Testimony: Advisory Committee on Reactor Safeguards

Joel Yellin  
Associate Professor of Social Science  
M.I.T.

Safety Study

Frank von Hippel  
Program on Nuclear Policy Alternatives  
Center for Environmental Studies  
Princeton University

Figure 2

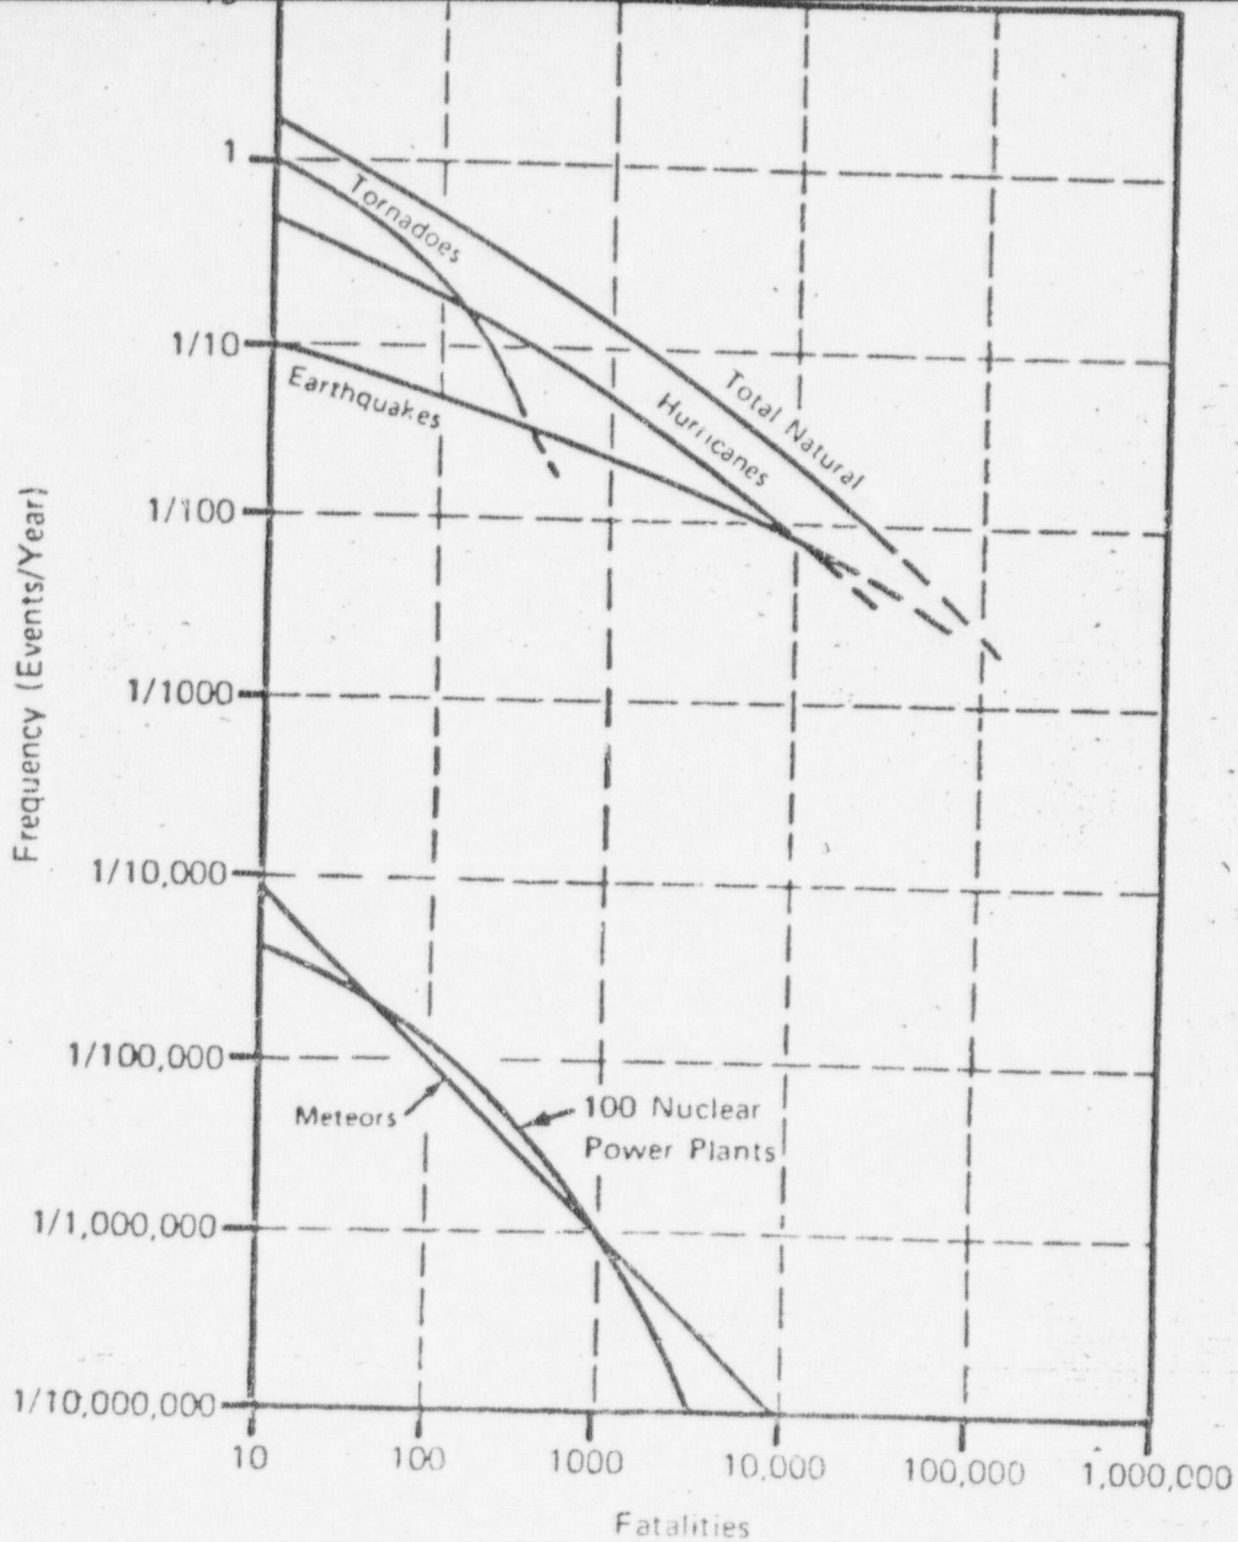
In Figure 2 I show the famous comparison of reactor hazards with natural events in the Executive Summary. This comparison appears to show that the hazard to the U.S. population from 100 reactors is of the same order of magnitude as that from meteors.

Unfortunately the comparison made here excludes from consideration all consequences of reactor accidents other than short term fatalities. In Figure 3 I show for the same probability level where Figure 2 shows 10 fatalities what some of the other consequences of reactor accidents were calculated to be in the RSS report. It appears to me that to say that 10 people died would be to inadequately report such events.

Figure 4

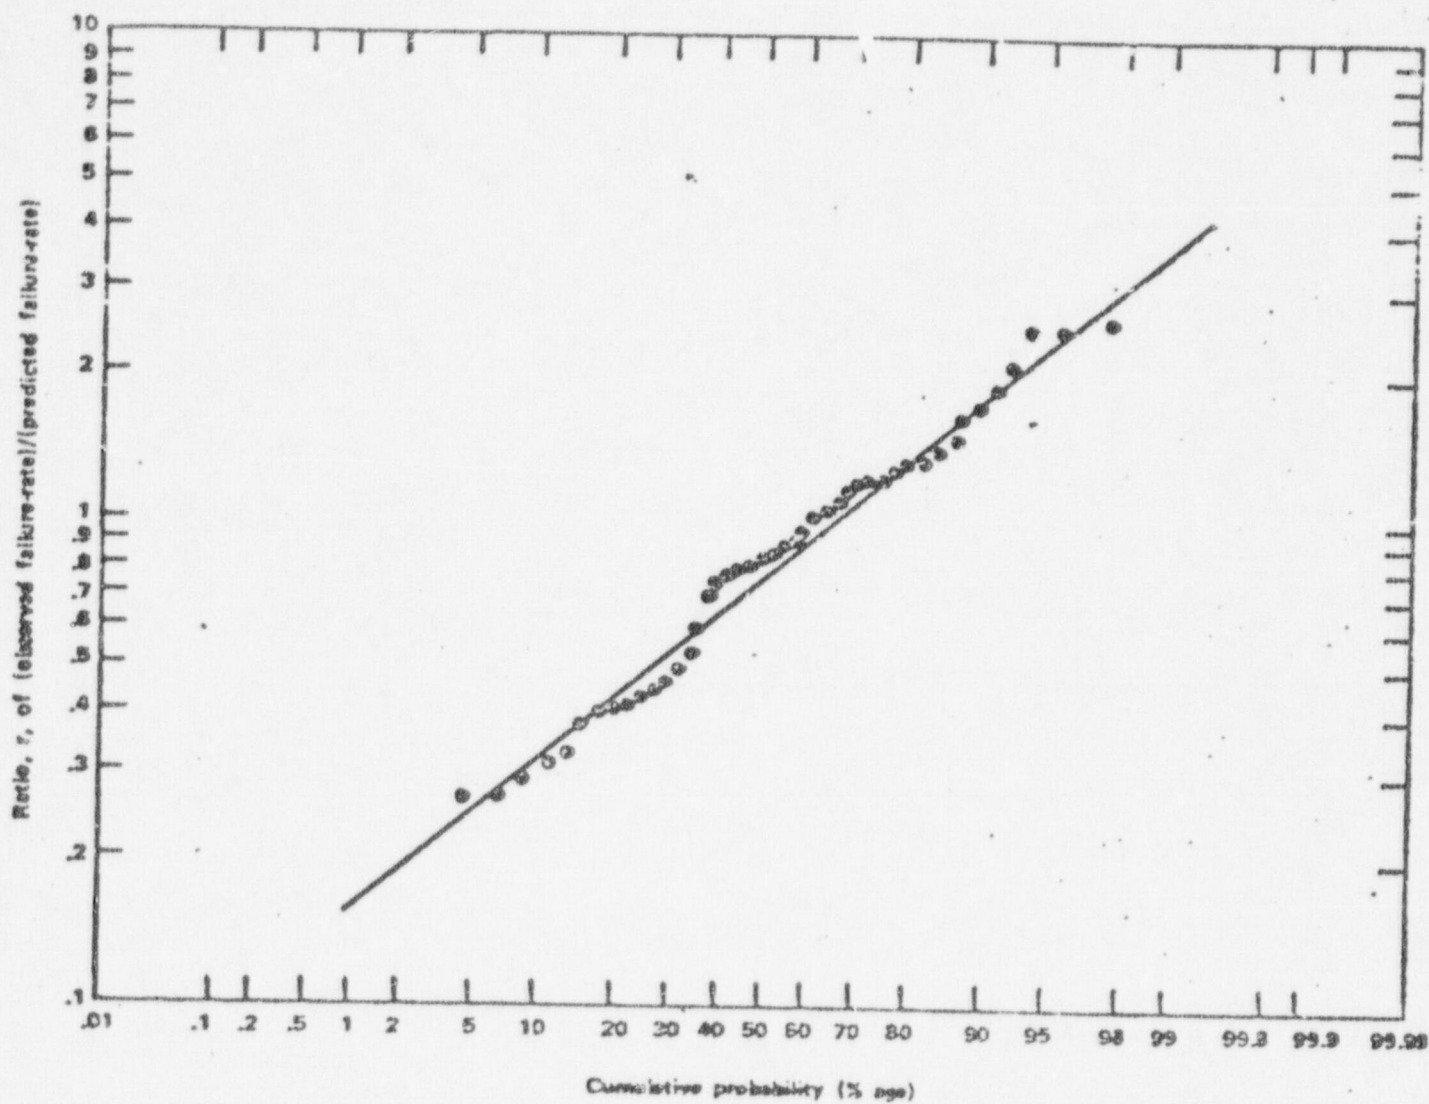
In the final RSS report\* the graph shown in Figure 4 is offered in substantiation of the factor of 5 error. It shows the ratio of observed failure rates to predictions for about 45 systems as compiled by A.E. Green and A.J. Bourne of the National Centre of Systems Reliability in England. One of the members of our group, Mr. Robert Weatherwax, is a reliability engineer and was interested in this graph so he wrote to Mr. Green and asked him for a list of the systems to which these points correspond. Dr. Bourne wrote back providing references to those cases where the numbers had been published. Figure 5 shows a compilation of this data.\*\* It will be seen that the systems are mostly simple pieces of electronic or mechanical equipment where the failure rates range from 0.13 to 220 per year. It would appear to me that it is hardly justified to take success within a factor of five in predicting the failures of a system which is expected to fail of the order of once a year and expect the same success for events involving systems containing thousands of components of this type in intimate interactions with human beings and each other and which are predicted to have probabilities of failure of the order of once in ten thousand years. ii) There appears to be areas in which the RSS group decided that a particular accident initiator would contribute little to the total probability of melt-down accidents without adequate analysis. Let me give as an example the case of earthquakes. The estimates made in the RSS report\*\*\* of the probability of failing two safety systems were calculated on the basis of numbers given in a paper written by N.M. Nemark. This paper was not

FIGURE VI 13-7 Mortality probability for an affected population versus distance from reactor for two hypothetical weathers: stability category A, wind speed = 0.5 m/sec; stability category F, wind speed = 2.0 m/sec.

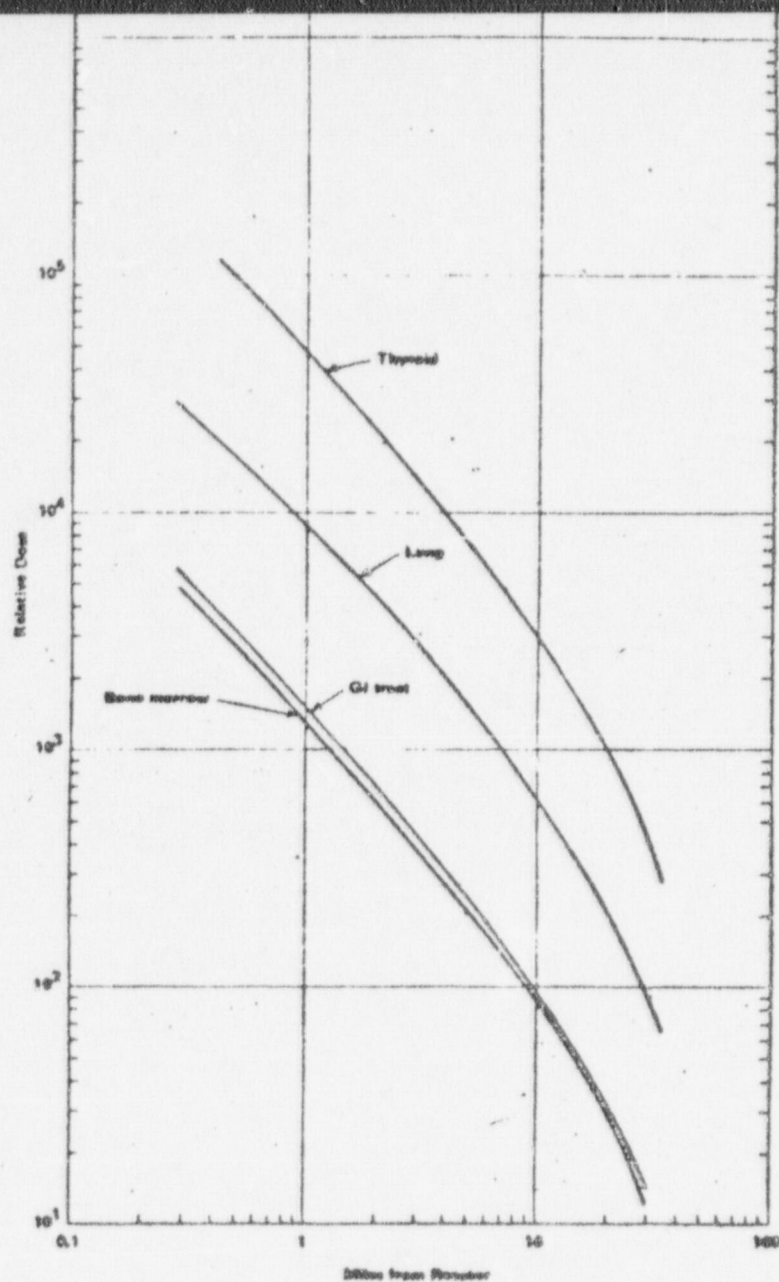
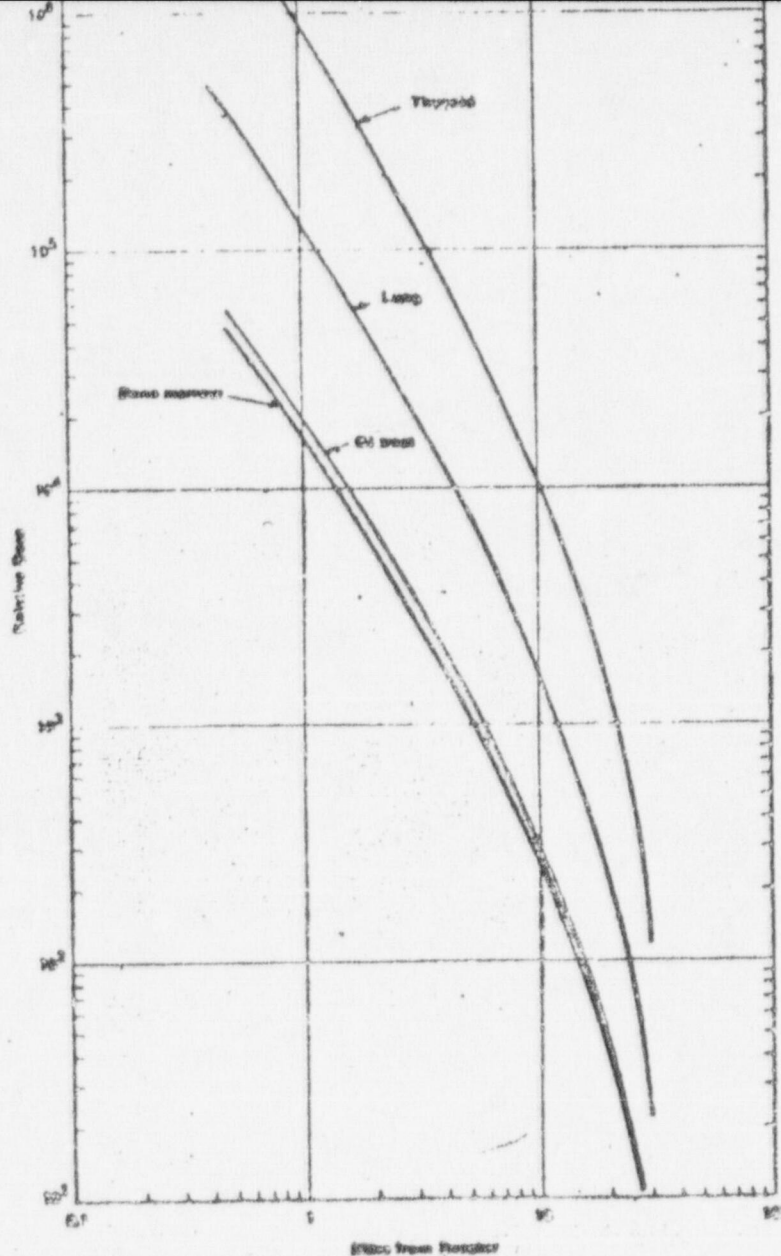
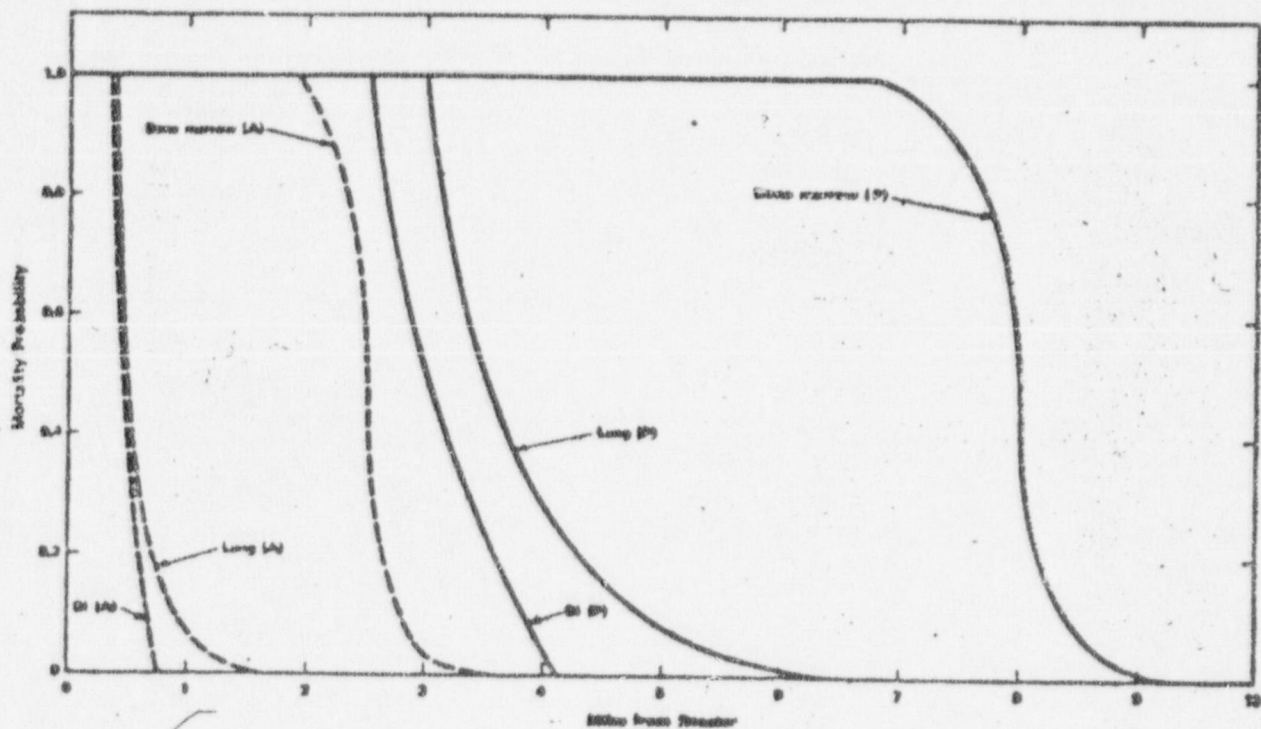
A constant question has been: "How far away from a major nuclear reactor accident would the population be in danger?" This information is at the core of the RSS group's calculations so we started by seeing if we could extract it from the report. All we found was three figures in Appendix VI which are reproduced in Figures 6, 7 and 8. Figures 6 and 7 show the one day doses to different organs of the population downwind for an unspecified accident for two different weather conditions. Figure 8 shows the corresponding probabilities of death for different distances downwind. Under the worse of the two weather conditions (F type weather) the lethal distance is about eight miles.

FIG 10

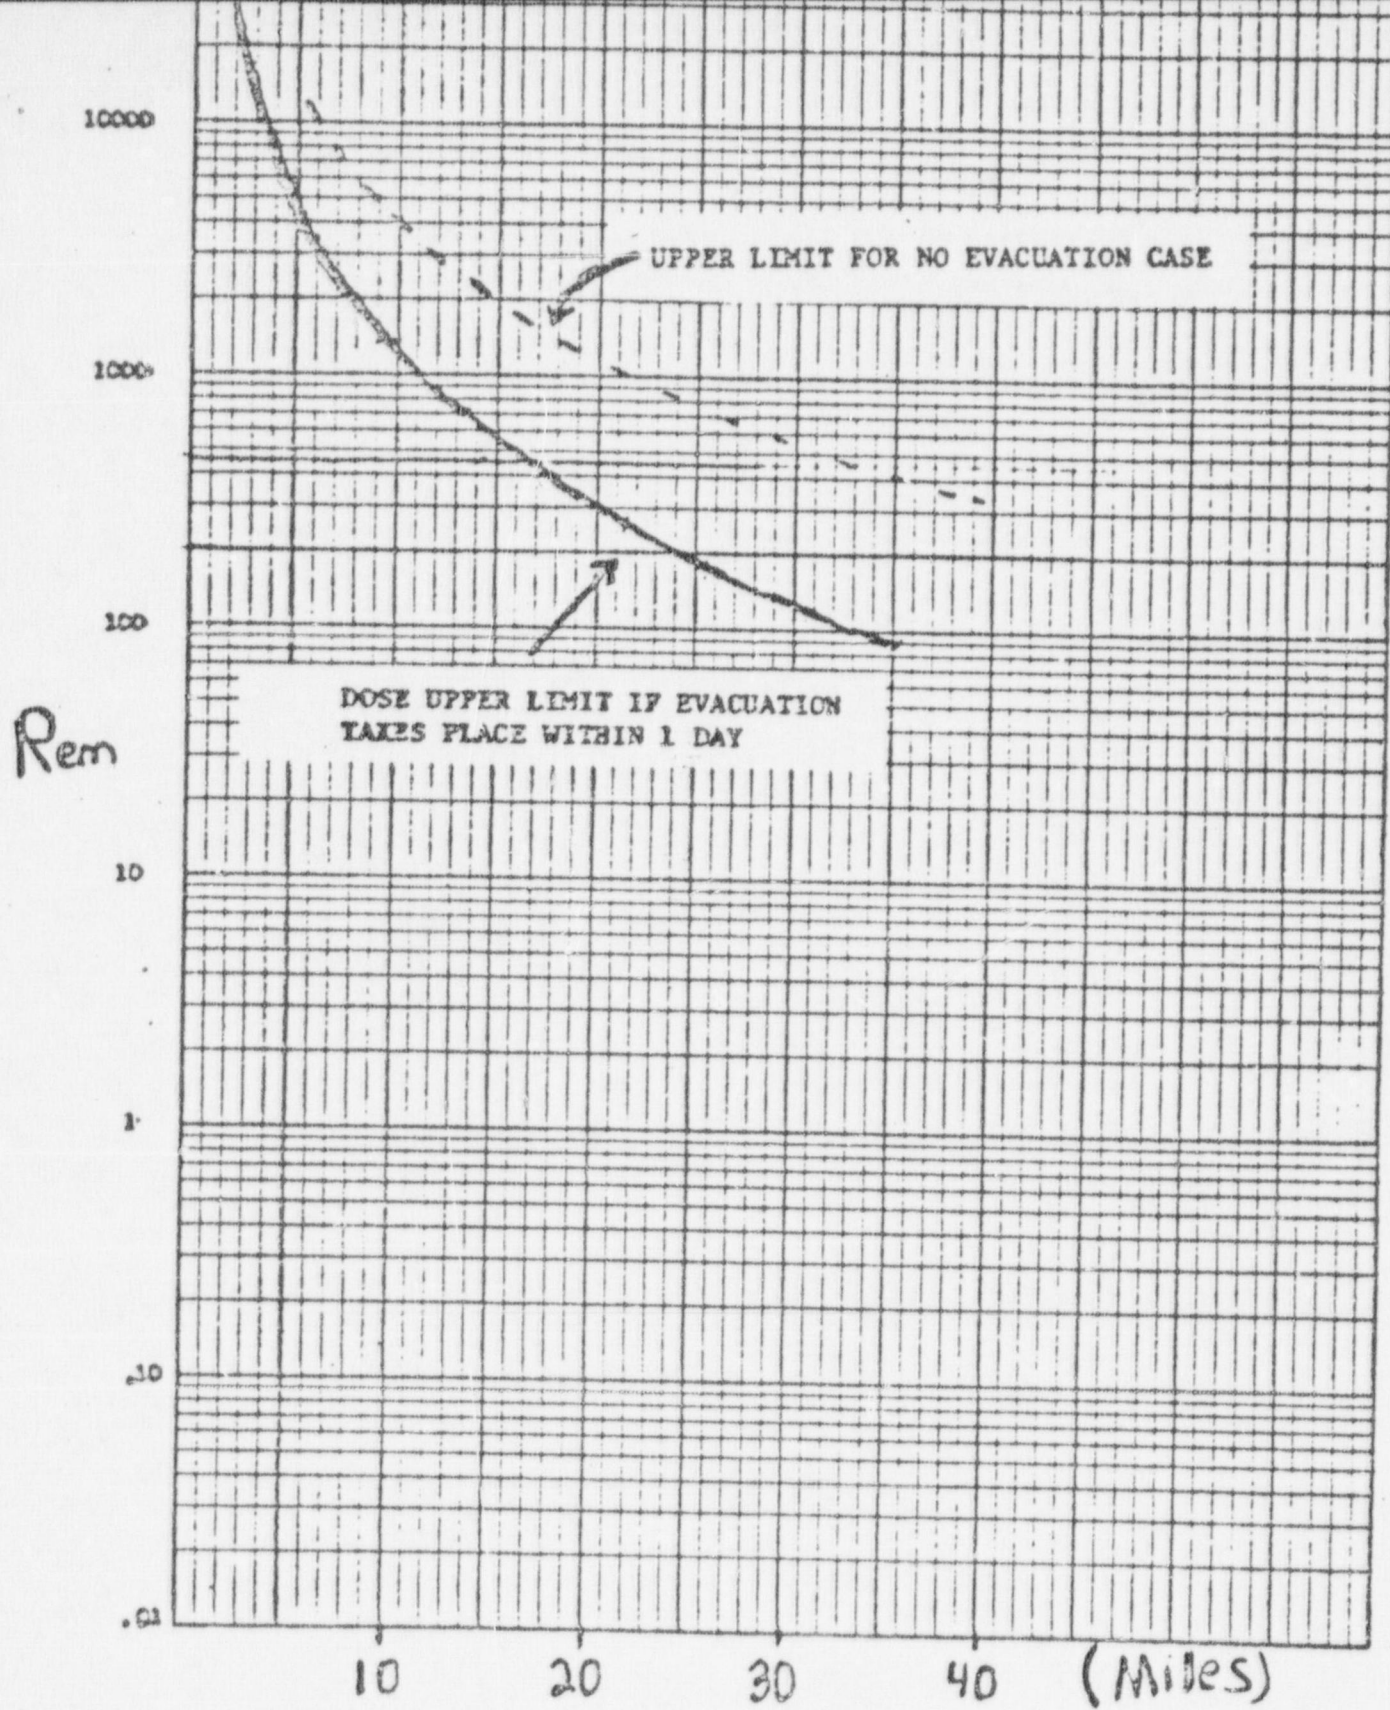
Does this mean that the population is safe beyond this distance? To find out we had to reproduce the RSS consequence computer program and test the sensitivity of its results to the various parameters. The following figures show results obtained by Dr. Beyea. As the curves in Figure 9 show, the results are quite sensitive to these parameters within the range of their uncertainties as given in the RSS report and, for particularly unfortunate combinations of initial plume height and deposition velocity, seven day bone marrow doses can reach 250 rem up to 40 miles downwind. Figure 10 shows the upper limit envelope to the one day and seven day doses calculated for time invariant weather. It will be
